3.10 CONTROL ROD AND POWER DISTRIBUTION LIMITS

Proposed Amendment No. 48
November 23, 1981

Figure TS 3.10-6

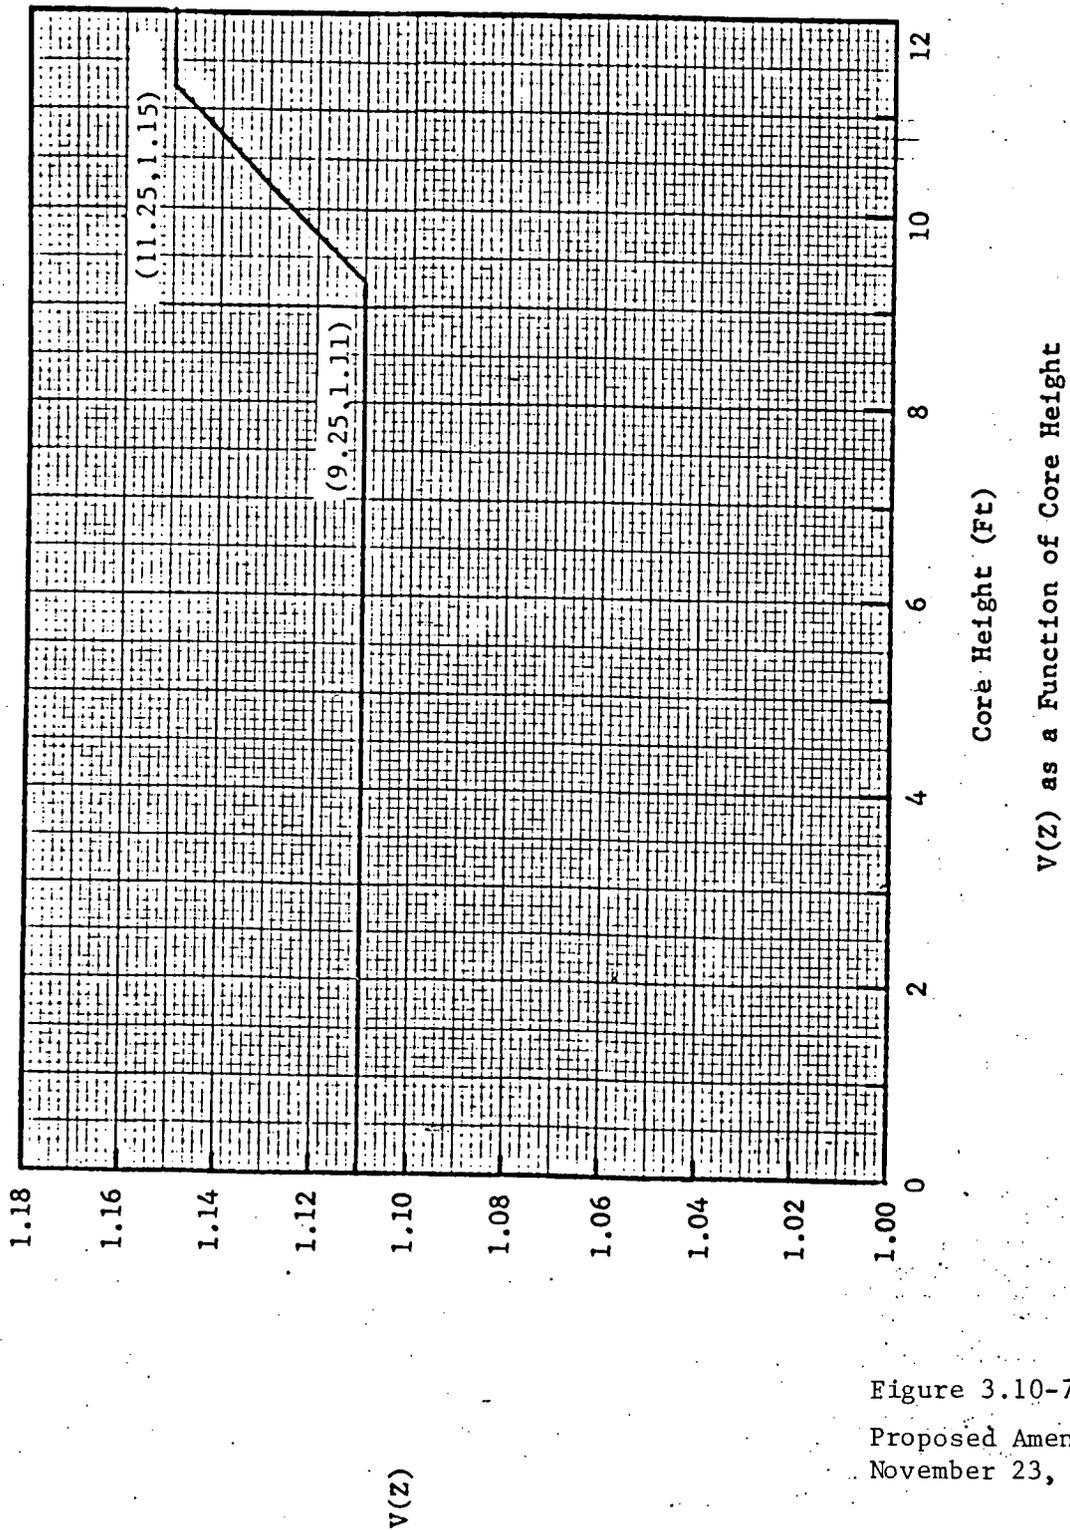
$$F_Q^N(Z) \times 1.03 \times 1.05 \leq F_Q^T(Ej)/P \times K(Z) \text{ for } P \geq .5$$

The $F_Q^N(Z)$ limits of specification 3.10.b.1.A include consideration of enhanced fission gas release at high burnup, off-gassing (release of absorbed gases), and other effects in fuel supplied by Exxon Nuclear Company; this results in an additional penalty in the form of the function $F_Q^T(Ej)$, as shown in Figure TS 3.10-6, which is applied to Exxon fuel. References 7 and 8 discuss these phenomena.
